5/5 KUMANOVO

DISPOSITION OF PROPOSED
OIL FUEL TANKS

S. S. Kumanova Miss
No. 492.

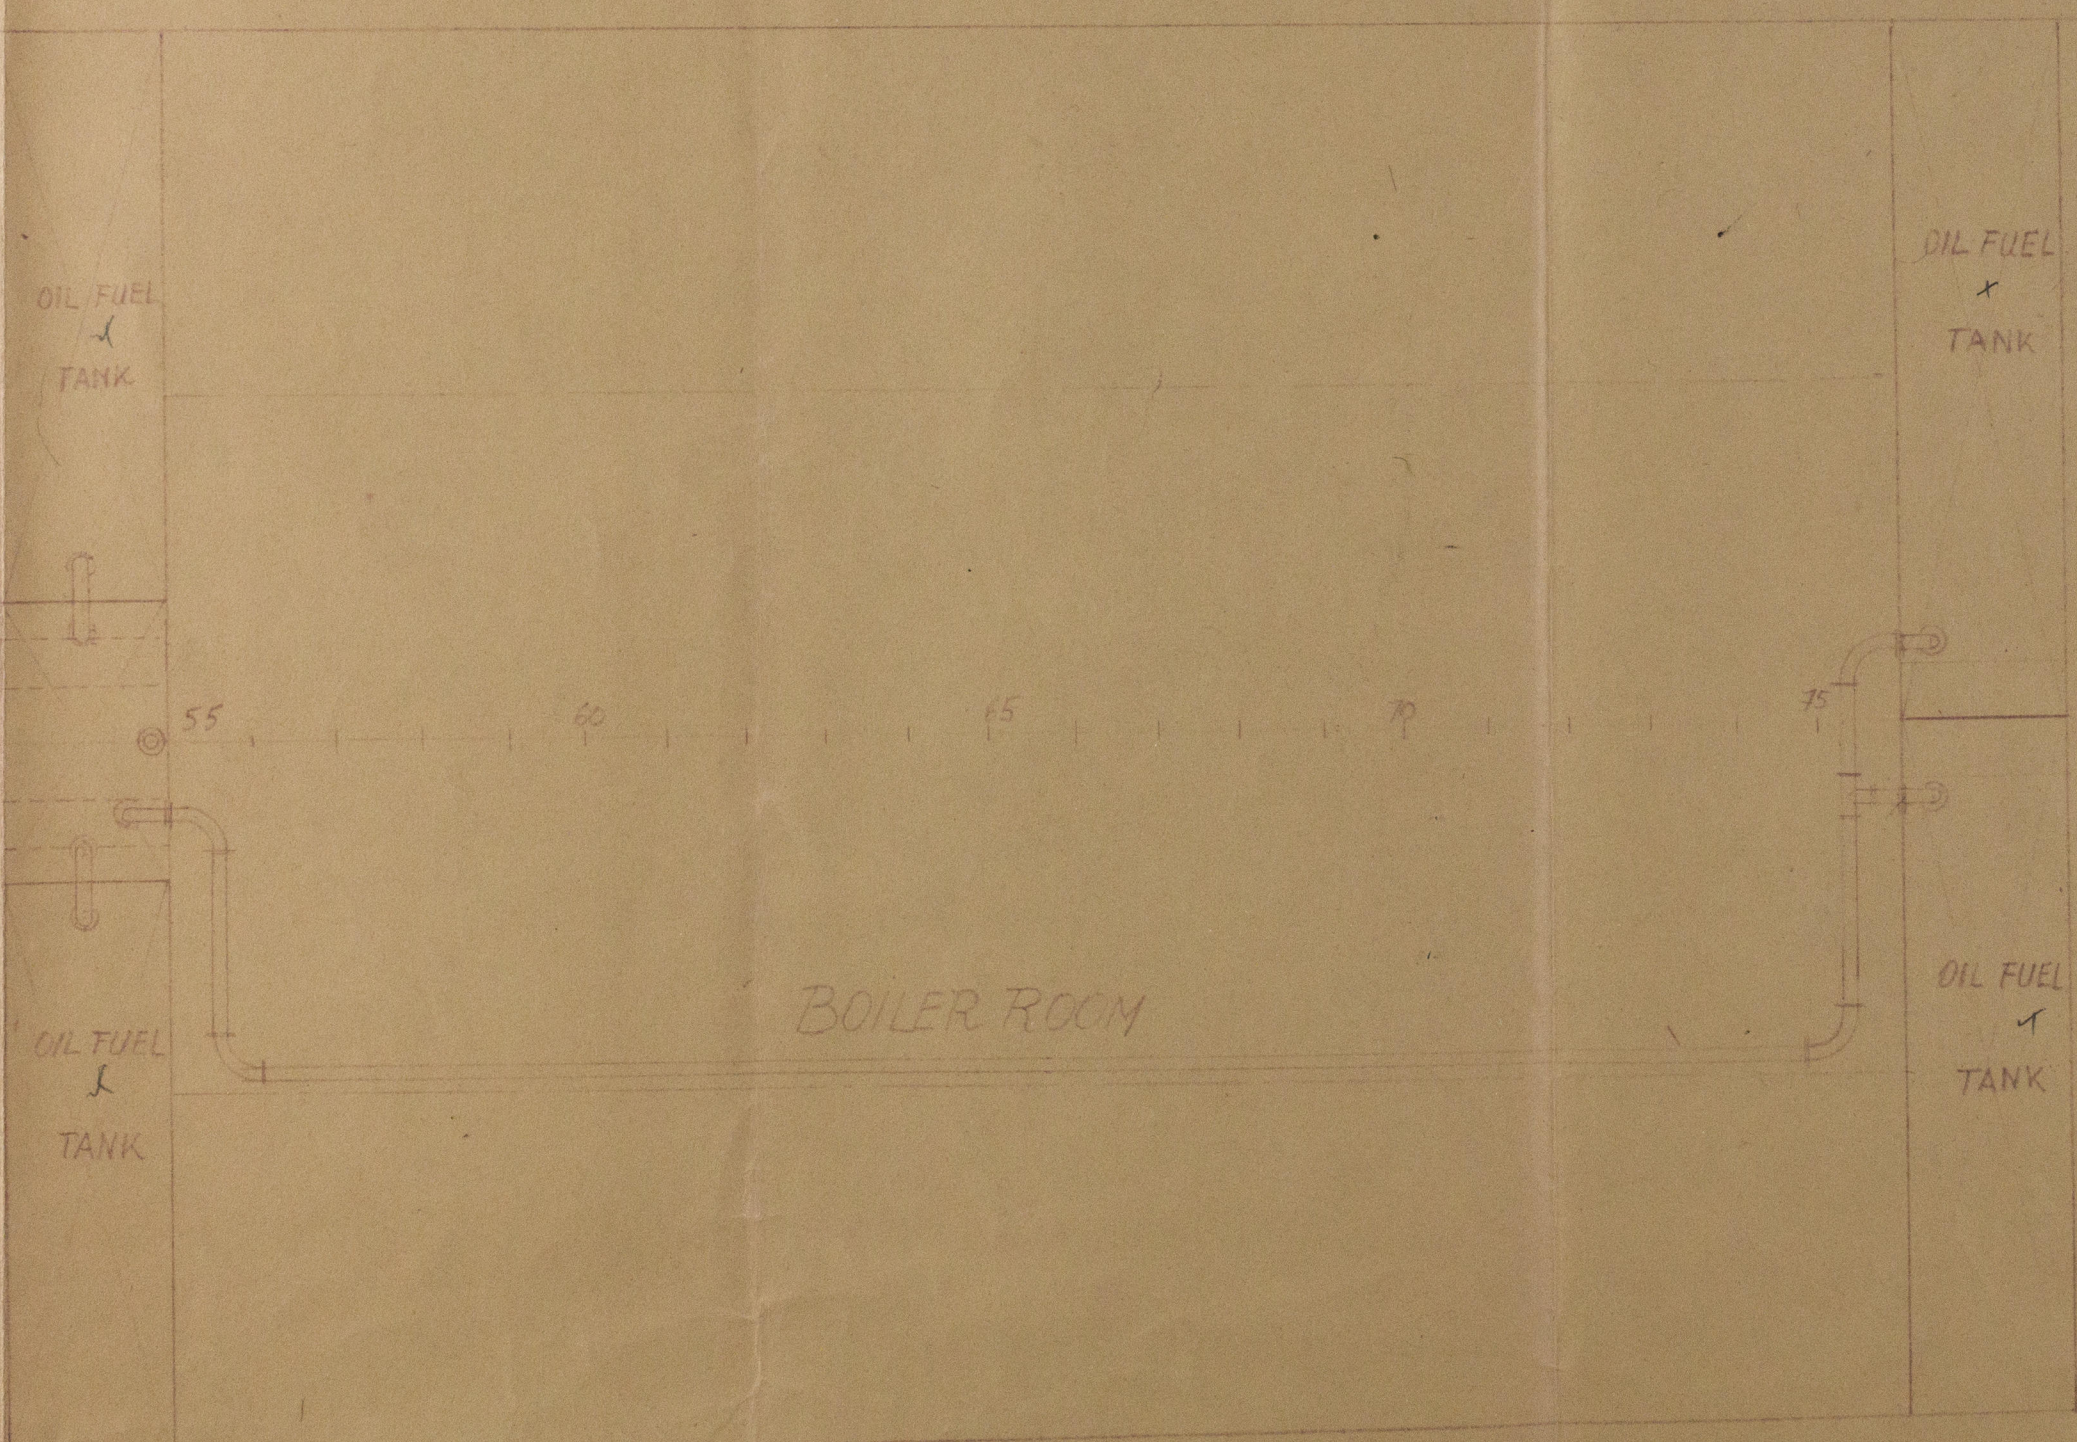
Size of air & overflow pipes
as per Section 20 D, bl. 2.
Provision to be made for sounding
tanks.
Plan of pumping arrangement to be submitted.
The flash point of the oil fuel to be above 100°F. and
the remaining requirements of Section 20 of the Rules
(1925-26) to be complied with so far as they are applicable.
